Project No. 15-004-01

Subject: CalAm Monterey Peninsula Water Supply Project, Draft Environmental Impact Report/Environmental Impact Statement, Prepared for California Public Utilities Commission and Monterey Bay National Marine Sanctuary, January 2017.

As requested, Hopkins Groundwater Consultants, Inc. (HGC) has reviewed the hydrogeology-related and alternatives portions of the Cal-Am Monterey Peninsula Water Supply Project (MPWSP or the “project”) Draft Environmental Impact Report/ Environmental Impact Statement (DEIR/EIS) prepared for the California Public Utilities Commission, dated January 2017, and is providing these comments for Marina Coast Water District’s (MCWD) consideration and use. In preparing these comments, we have reviewed the relevant portions of: (1) the DEIR/EIS; (2) the DEIR/EIS appendices; (3) references cited in the DEIR/EIS and DEIR/EIS appendices; (4) the calibrated model developed for the MPWSP and the application of the superposition model scenario constructed to evaluate the project; (5) the documents provided to HGC in response to MCWD’s data and public records act requests that were made available before March 27, 2017; and (6) publicly available in

<b>HOPKINS GROUNDWATER CONSULTANTS</b>	<b>FIGURE 1</b> <b>AVERAGE CHLORIDE CONCENTRATIONS</b> <b>DUNE SAND AND</b> <b>180-FOOT AQUIFER</b>

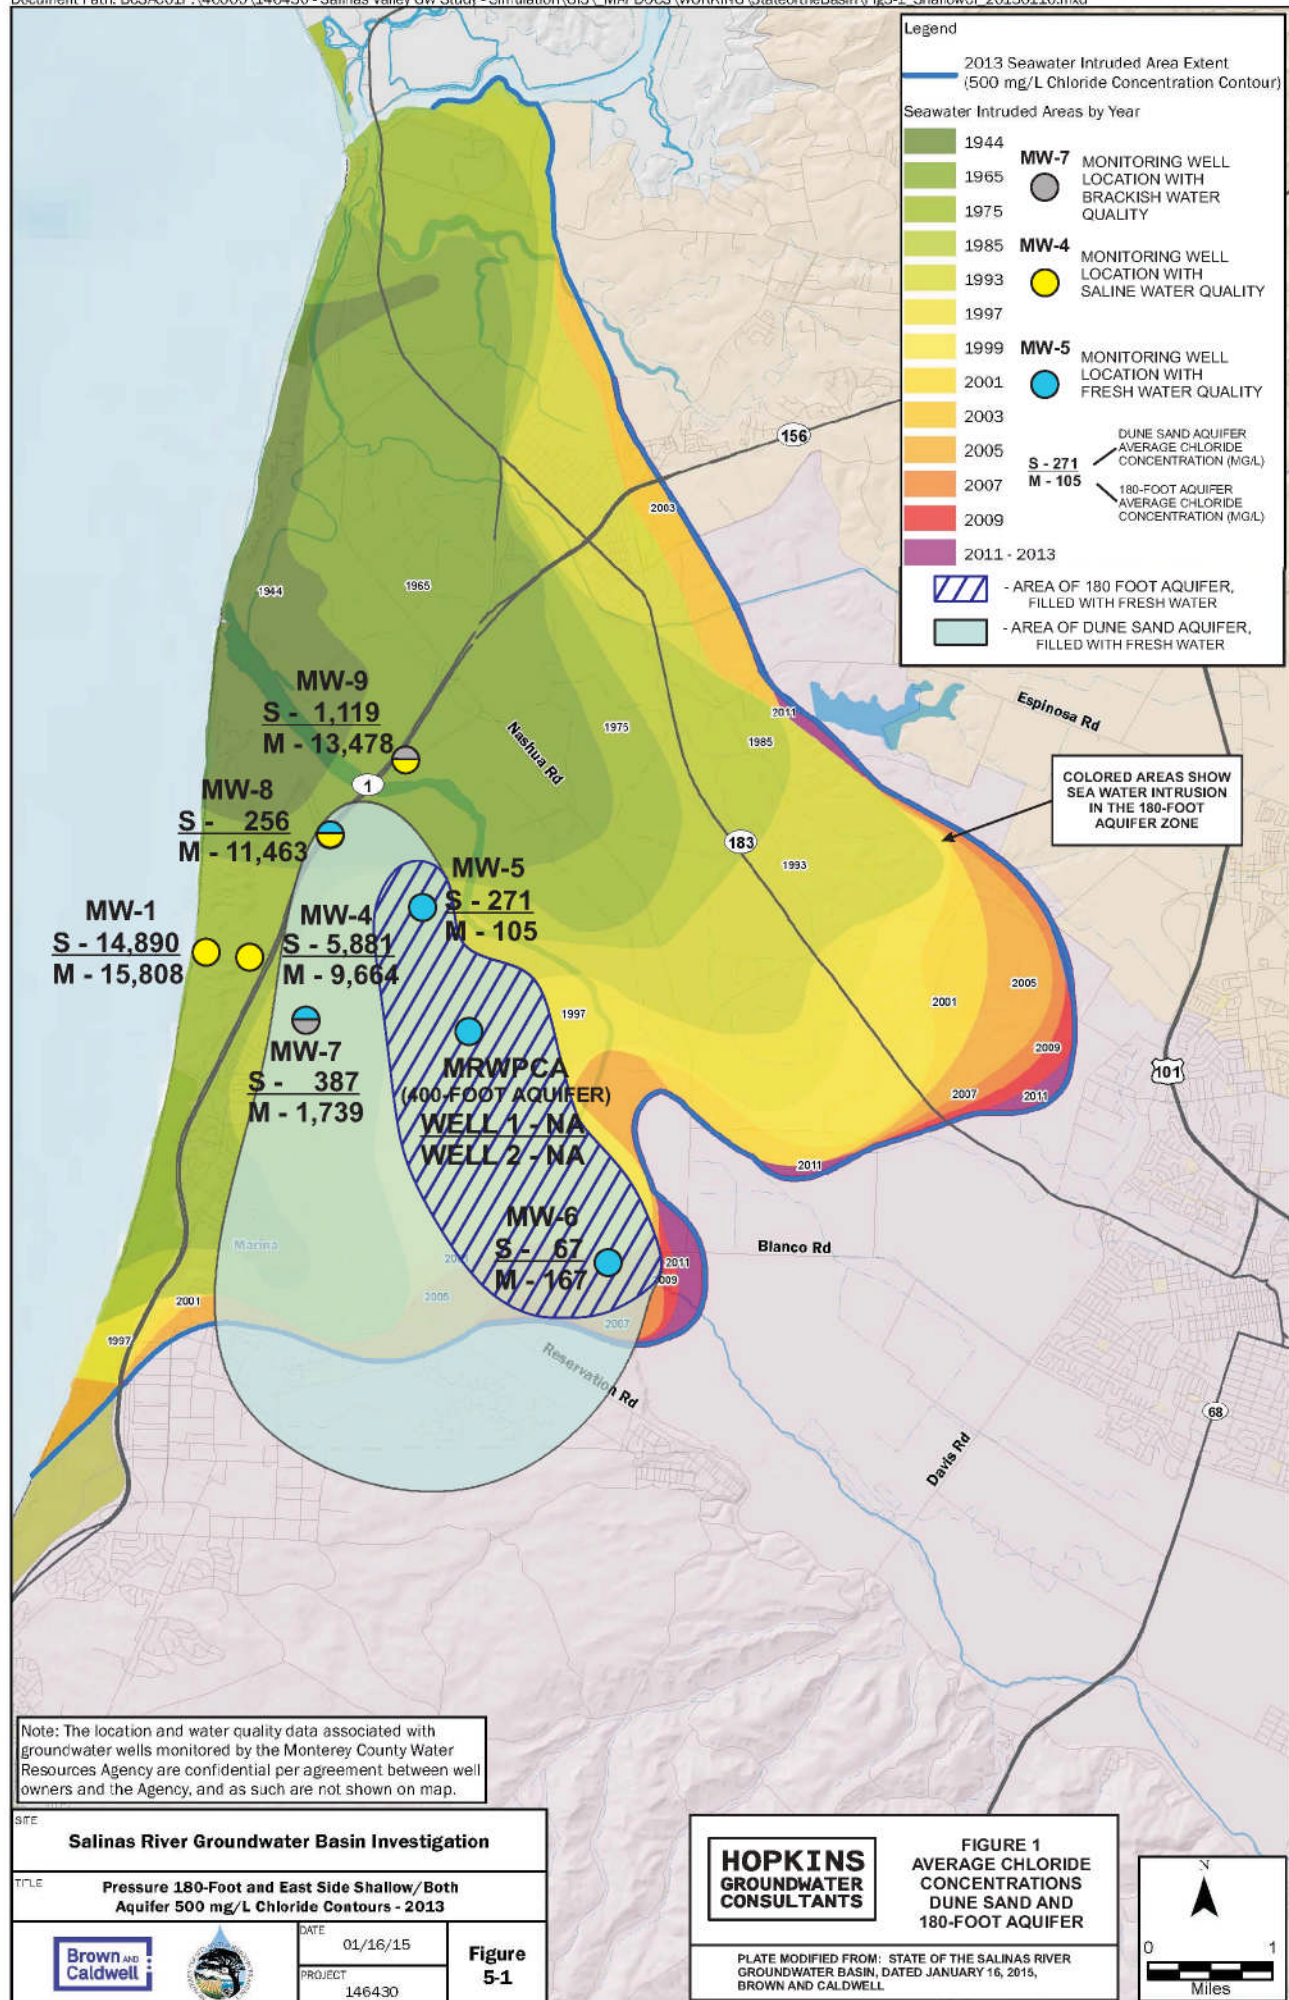
Figure 1 – Average Chloride Concentrations, Dune Sand and 180-Foot Aquifer (attached to these comments) shows the location of the wells being monitored for the TSW project. As shown, the chloride concentrations in the 180-Foot Aquifer decrease from 9,664 mg/l in MW-4M to 105 mg/l in MW-5M, which is in the middle of the reported zone of seawater intrusion that is defined by a chloride concentration of 500 mg/l (B&C, 2015). Figure 2 – Average Total Dissolved Solids Concentrations, Dune Sand and 180-Foot Aquifer (attached to these comments) shows this same trend in the average TDS values obtained from available laboratory data (Geoscience, 2015p) and unpublished data provided by the CPUC in response to an MCWD data request, which we understand MCWD will include with its comments.

The statements regarding seawater intrusion into the 180-FTE Aquifer are only partially correct and thus misleading. The DEIR/EIS’s statement that the 180-FTE Aquifer groundwater has been degraded (a relative term) by legacy and ongoing seawater intrusion is accurate, but the suggestions that it is completely intruded to about 4 miles inland is false. As previously explained, the TSW findings show that inland of the project location this aquifer has fresh water at MW-5 and MW-6 (see attached Figures 1 and 2).
